**CITY OF AUSTIN**  
**APPLICATION TO BOARD OF ADJUSTMENT**  
**GENERAL VARIANCE/PARKING VARIANCE**

STREET ADDRESS: 1700 S. 6th Street Austin, TX 78704

a new residence with a variance for a front yard set-back of 15'-0" and a side yard setback on the north side of the property for 0'-0", for the property listed at 1700 S. 6th S t .

CASE#: C15-2010-0060  
 ADDRESS: 1700 S 6TH ST  
 GRID: H20  
 MANAGER: SUSAN WALKER

**GONZALEZ RESIDENCE**  
1700 S. 6TH ST.  
AUSTIN, TX 78704

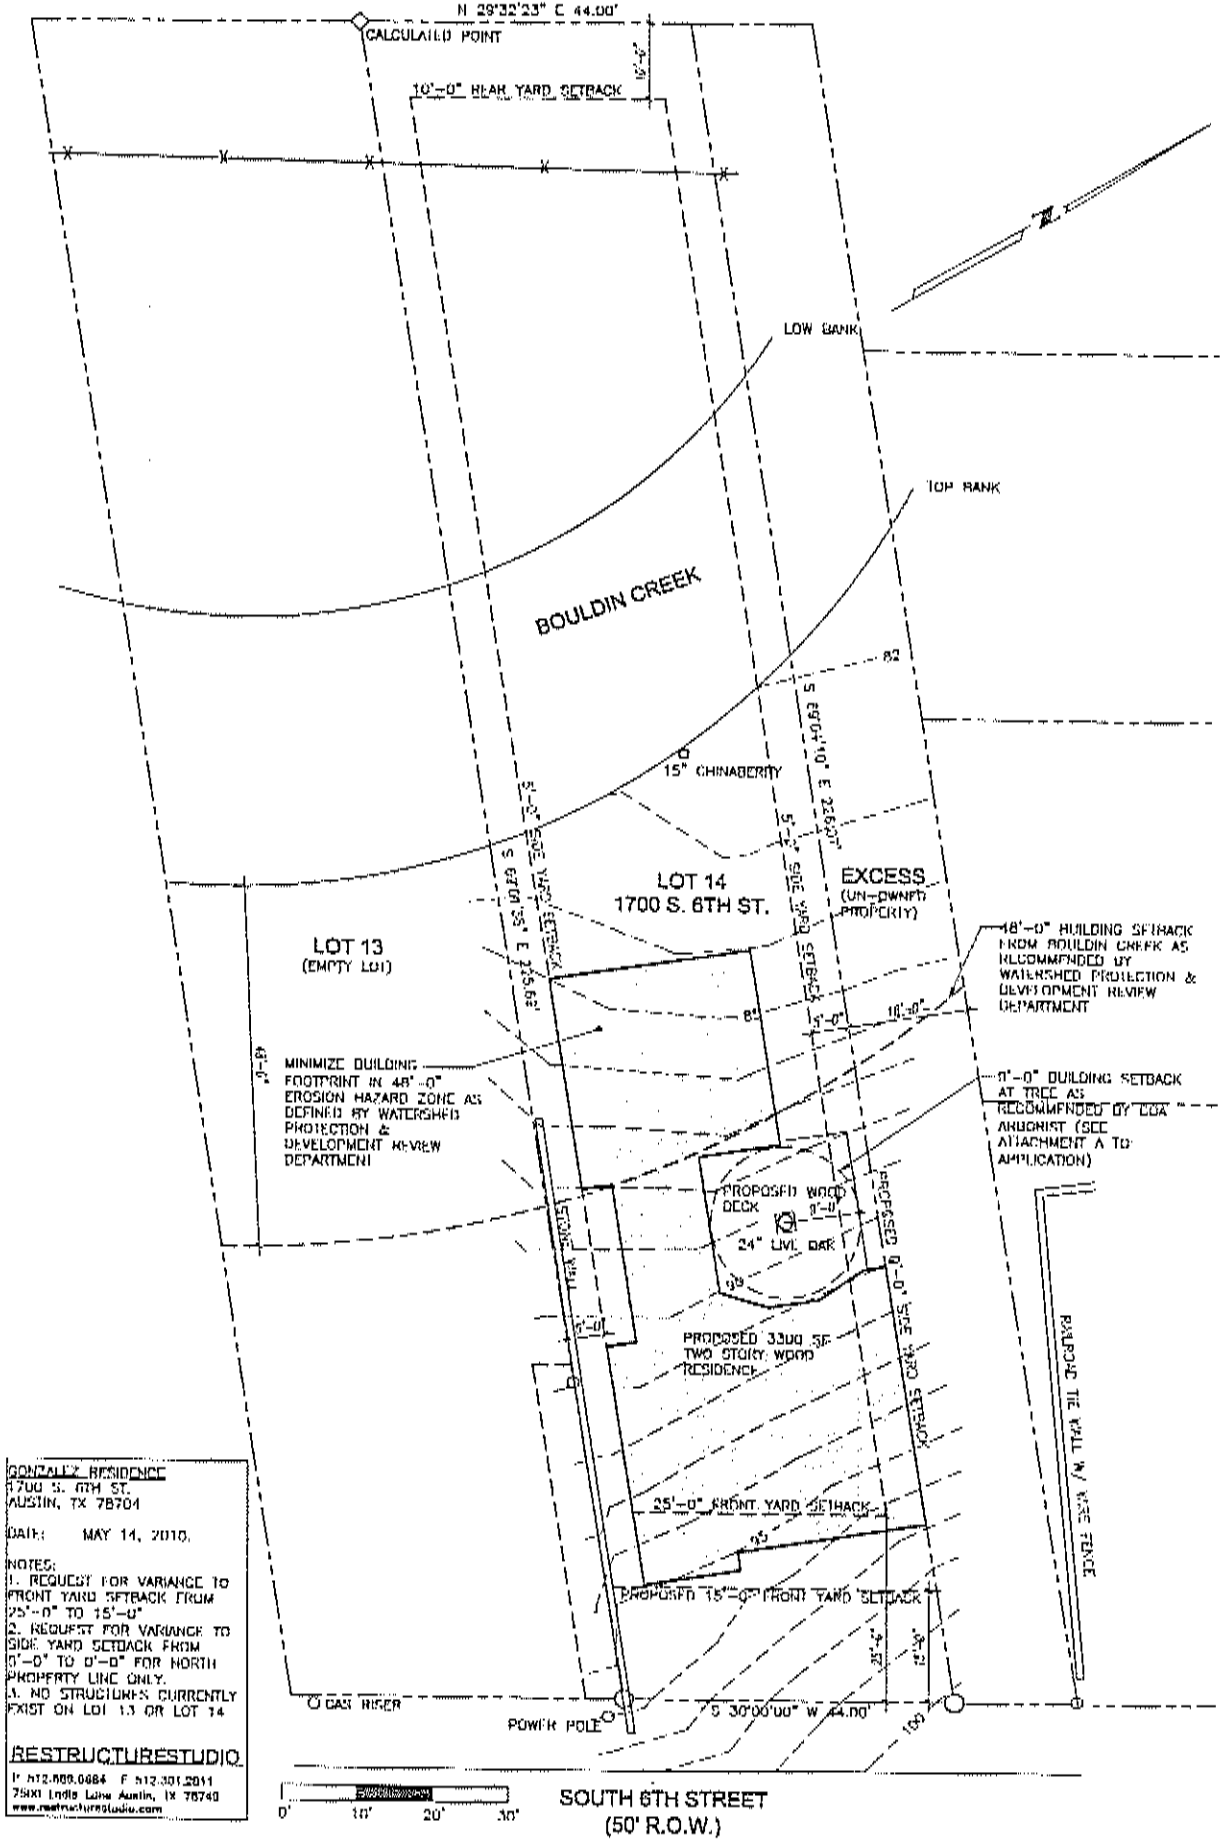
Austin Energy (AE) has reviewed your application for the above referenced property requesting a 15 foot front yard set back and 0 feet side yard set back. Austin Energy has no conflicts with this application as requested and shown on the attached red-stamped sketch.

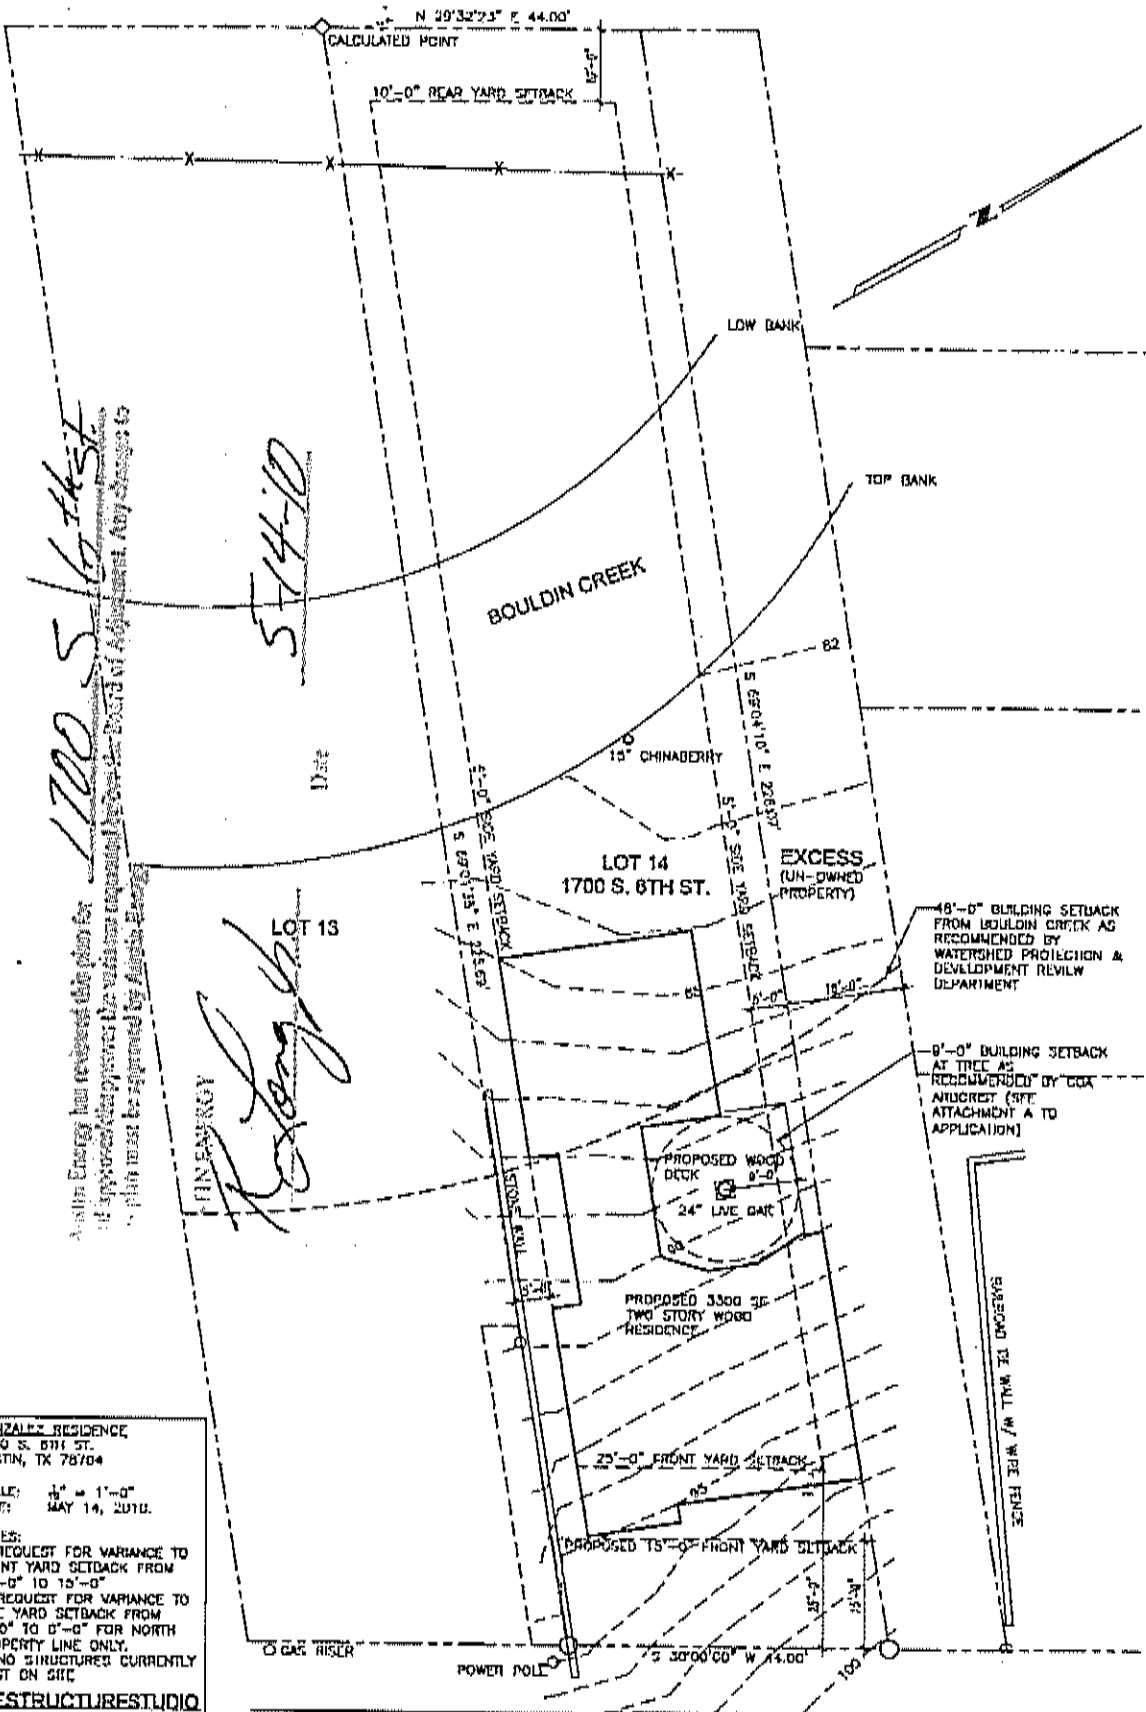
Austin Energy has reviewed this plan for  
 its approval they reserve the right to request changes to  
 this plan must be approved by Austin Energy
